City Of Saint Paul
Department Of Public Works
Bureau Of Construction and Repairs

Address 24 E. 4th Street

STATE AID FOR LOCAL TRANSPORTATION
CHANGE ORDER

SP 164 -136 - 01T	Minn. Proj. No.	()	CO No. 14
Project Location: FOURTH STREET			
Local Agency CITY OF SAINT PAUL		Local Project No. 12-P-1363	
Contractor Thomas and Sons Construction, Inc.		Contract No.	
Address/City/State/Zip 13925 Northdale Blvd. / Rogers / Mn / 55374			
Total Change Order Amount \$ 6,930.00

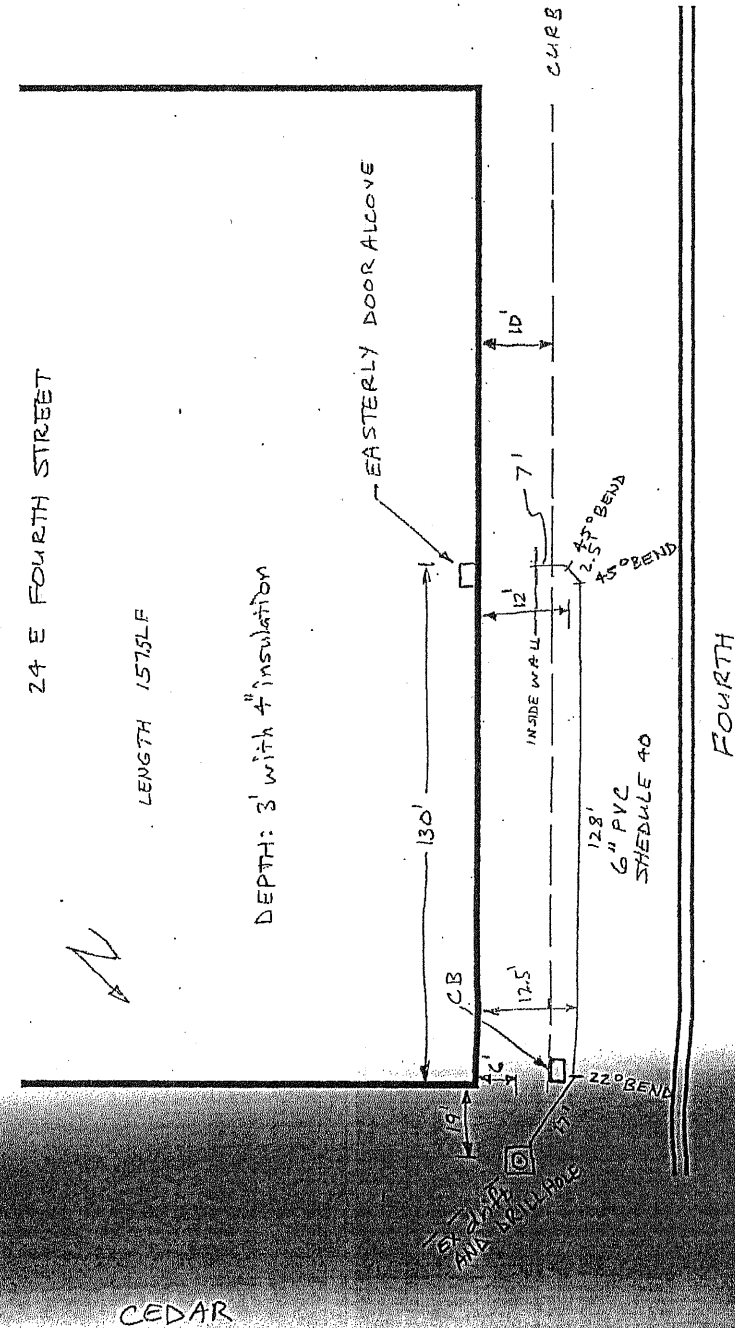
Remarks STORM SERVICE from MH with
DRILL HOLE AT SE CORNER OF 4th
AND CEDAR to areaway
3' Deep (on top of Rock)
4" of Insulation over Pipe

The Contract did not provide for the construction storm services. A storm service was needed to connect 24 East Fourth Street to MH 9.

Extra work was needed to construct 161.5 LF of storm service. The work was reasonable and justified, and this constitutes a changed condition for which the Contractor is due compensation. This cost will be assessed to the property owner.
